# 2022/1892/P – Building R8

<b>Delegated Report</b>		<b>Analysis sheet</b>		<b>Expiry Date:</b>		01/07/2022			
<b>(Members Briefing)</b>		N/A		<b>Consultation Expiry Date:</b>		05/06/2022			
<b>Officer</b>				<b>Application Number(s)</b>					
Patrick Marfleet				2022/1892/P					
<b>Application Address</b>				<b>Drawing Numbers</b>					
Plot R8 King's Cross Central York Way London				See draft decision notice					
<b>PO 3/4</b>		<b>Area Team Signature</b>		<b>C&amp;UD</b>		<b>Authorised Officer Signature</b>			
<b>Proposal(s)</b>									
<p>Amendments to reserved matters approval ref 2020/5143/P dated 09/02/2021 (Reserved matters relating to Building R8 for the erection of two, 13 storey buildings comprising office space (Class B1) and 72 Social Rented Affordable residential units, as required by conditions 9, 10, 12, 14, 16-22, 24, 27, 28, 31, 33-39, 42, 42A, 43, 45, 46, 48, 49, 50A, 51, 56, 60, 61, 64-67 67 of outline planning permission reference 2004/2307/P granted 22/12/06 (subject to S106 agreement) for a comprehensive, phased, mixed-use development of former railway lands within the King's Cross Opportunity Area)</p> <p>Namely, alterations to the approved facades and core,

## 2. Proposed west façade

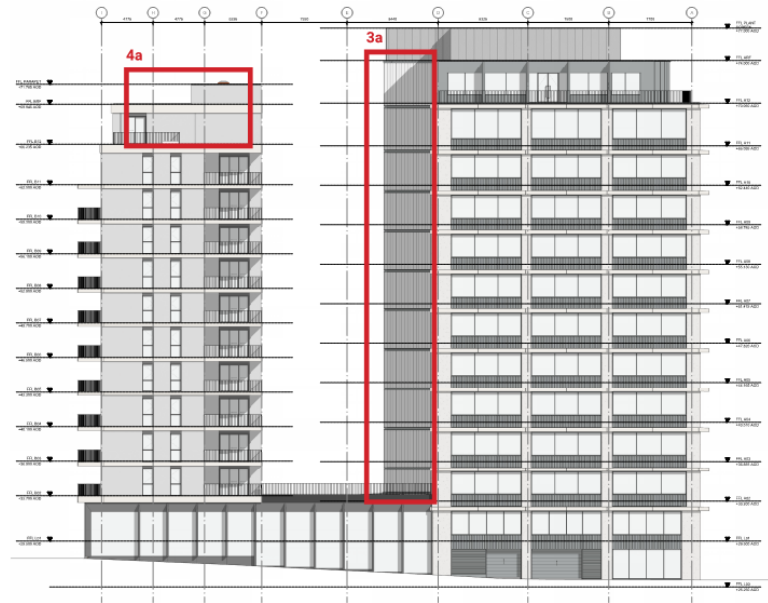
- 1a Additional external door on L01 added to façade south of reception
- 1b Additional external door on L01 added to façade north of reception
- 1c Additional three external doors added to L12
- 1d L00 glazing to retail unit changed to an operable façade

### 4. Proposed north façade

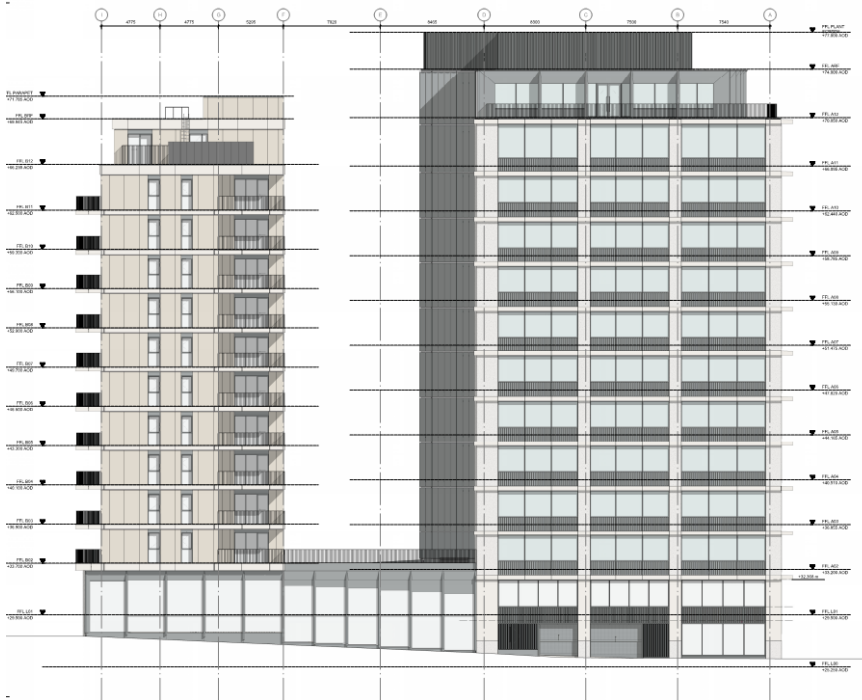
3a Core façade cladding updated to bespoke perforated metal rainscreen cladding

4a Plant for fire ventilation and walkways added to roof levels

**6. Proposed south façade**

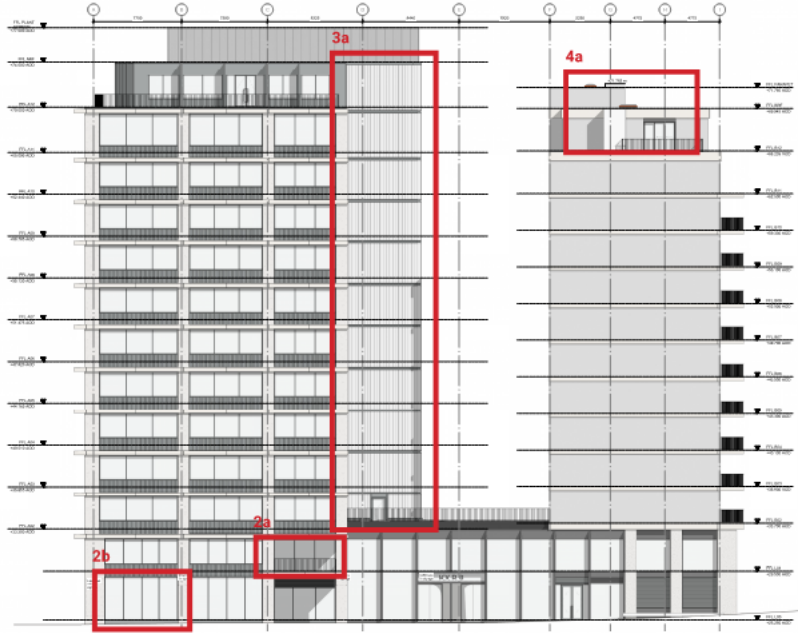
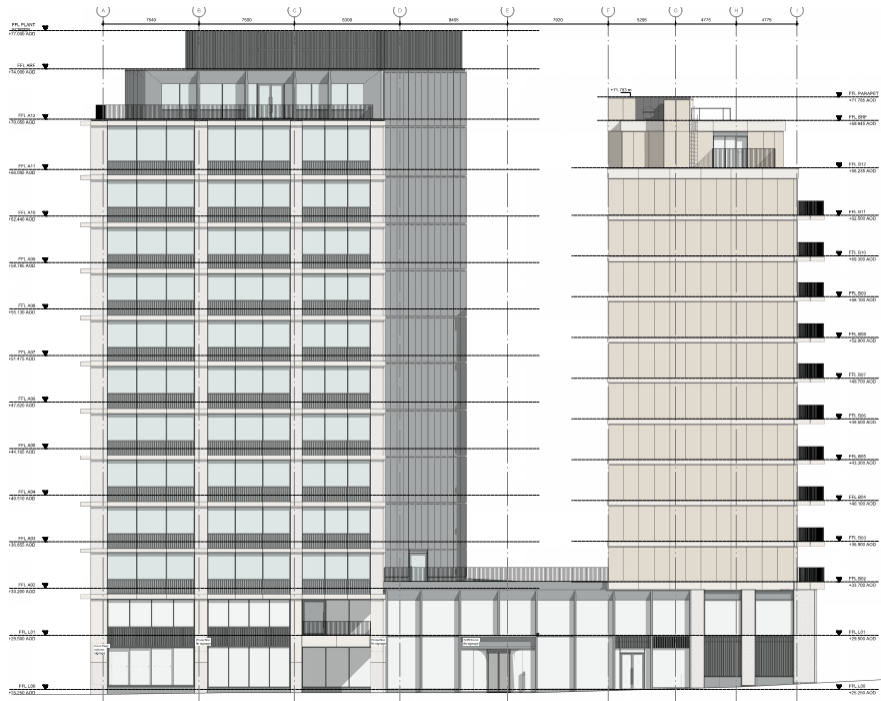
- 2a Double door moved southern face of southern façade at L01
- 2b L00 glazing to retail unit changed to an openable façade
- 3a Core façade cladding updated to bespoke perforated metal rainscreen cladding
- 4a Plant for fire ventilation and walkways added to roof levels

**8. Proposed east façade**

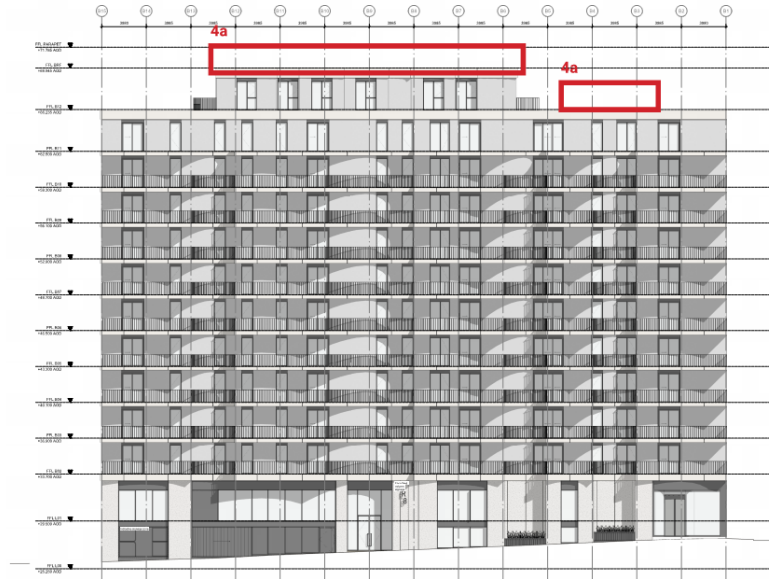
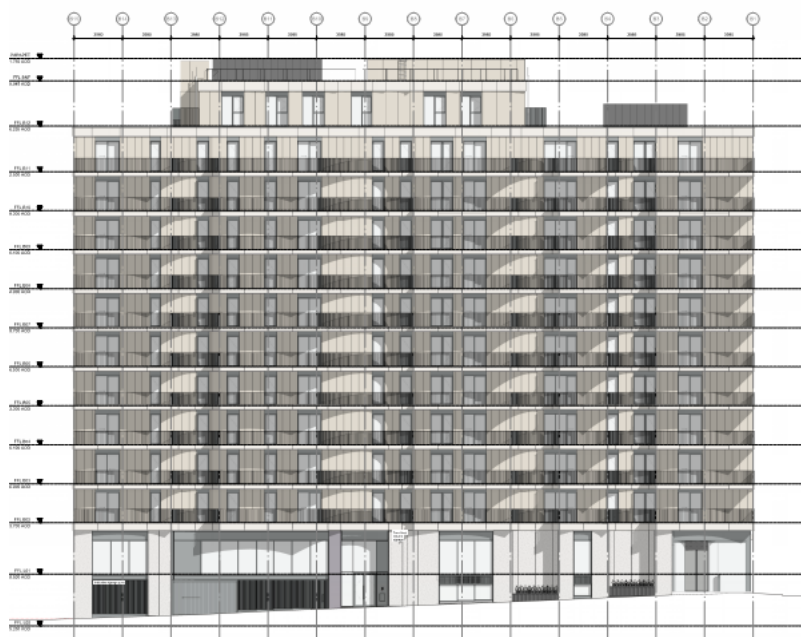
4a Plant for fire ventilation and walkways added to roof levels

## 10. Proposed eastern basement

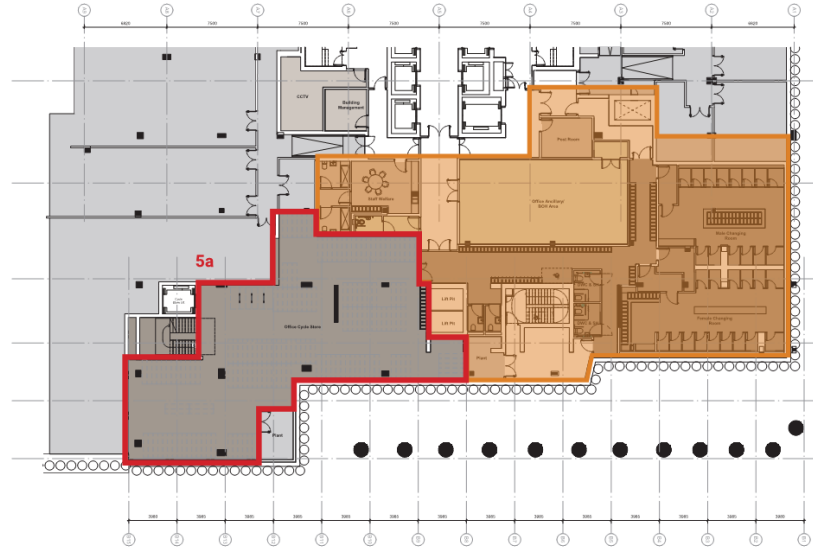
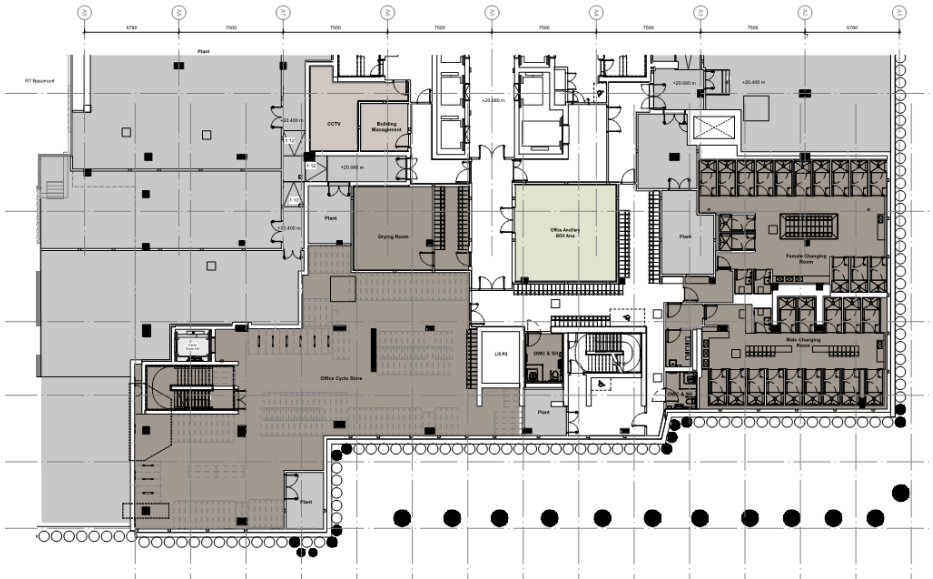
5a Office (combined) - 308 (142 2-tier josta-style units, 16 Sheffield stand spaces, 8 vertical wall racks), 1 scooter spaces with charging points

NOTE: Area highlighted in orange has been updated, but does not affect the application. Showers and WC's remain the same.
